VIRGINIA ELECTRIC AND POWER COMPANY  
RICHMOND, VIRGINIA 23261

**VIRGINIA ELECTRIC AND POWER COMPANY**  
**SURRY POWER STATION UNITS 1 AND 2**  
**REVISIONS TO STATION EMERGENCY PLAN**  
**REVISIONS TO EMERGENCY PLAN IMPLEMENTING PROCEDURES**

**ATTACHMENT 2**  
**SURRY EMERGENCY PLAN REVISION 38 SUMMARY**

SURRY POWER STATION  
10 - MILE EMERGENCY PLANNING ZONE (EPZ)  
FIGURE 6.2

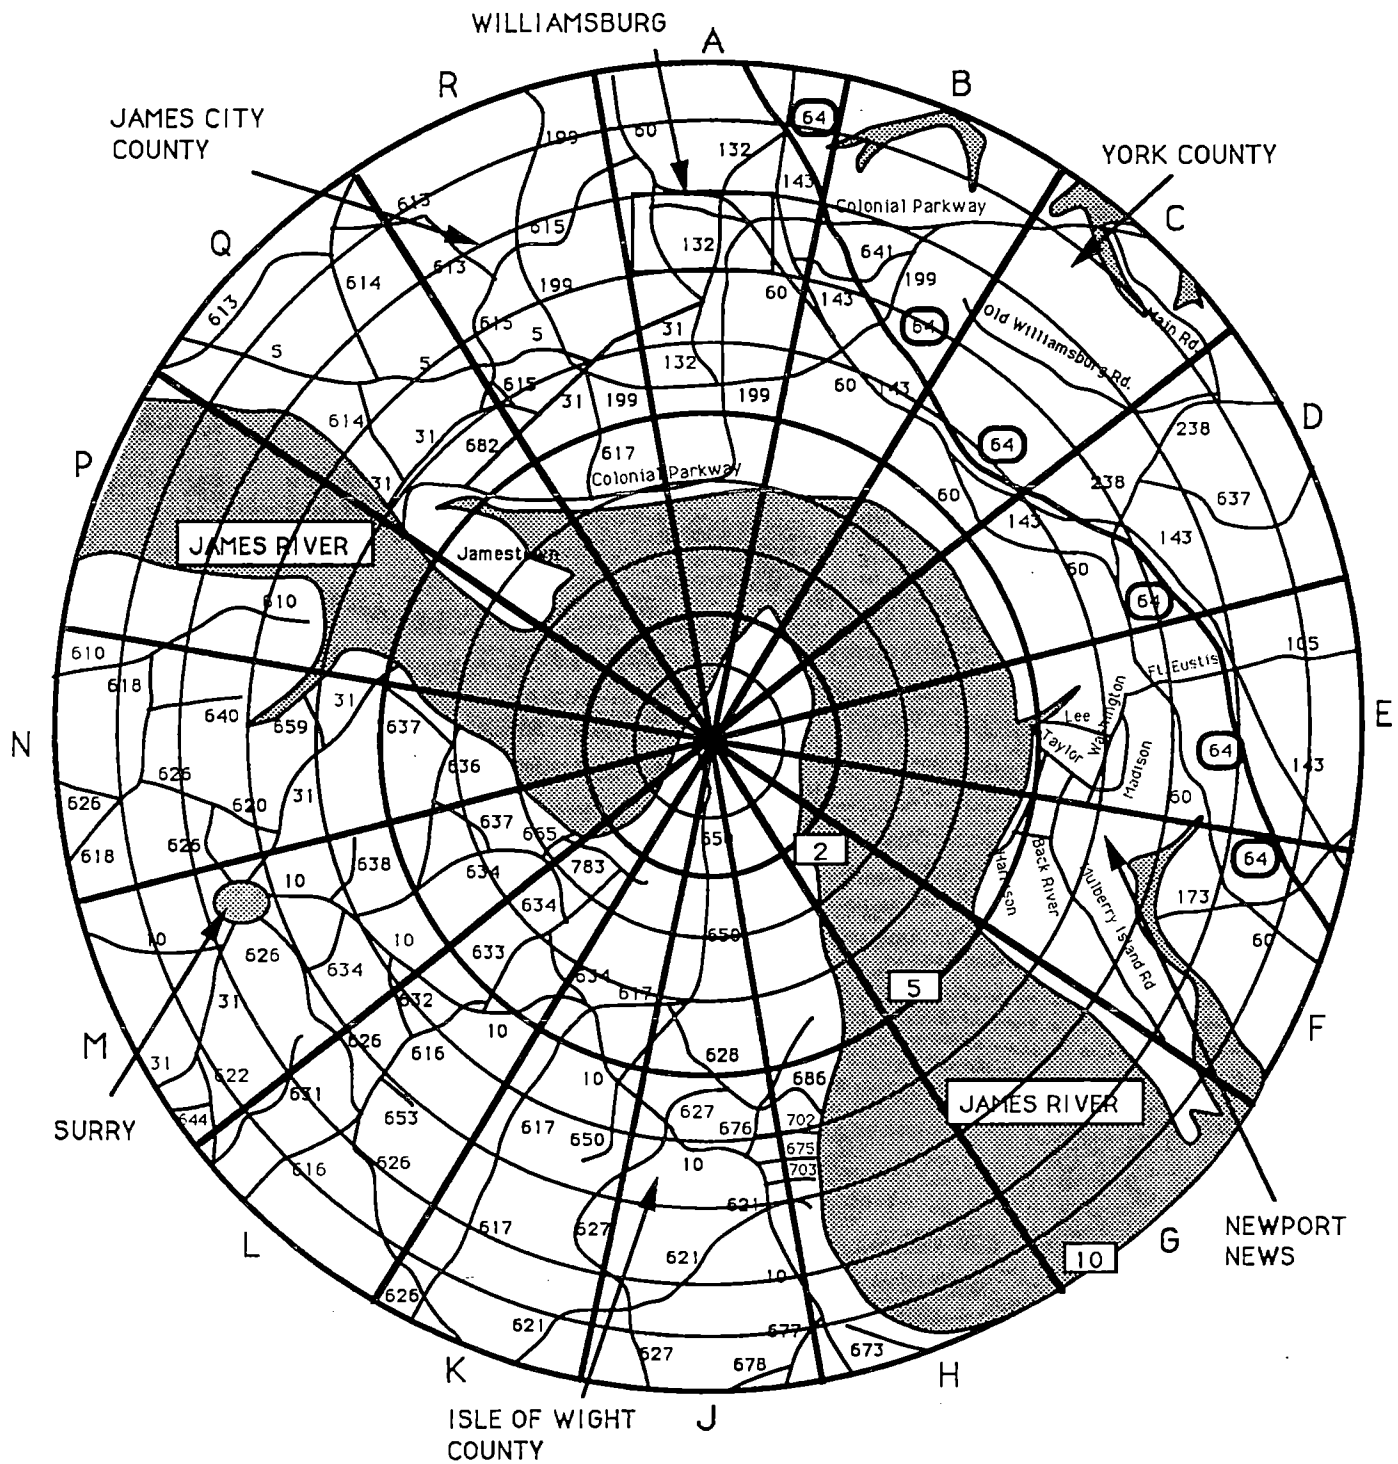
Page 6.12:

Added degree designations to sector wind spider on 10 mile EPZ map.
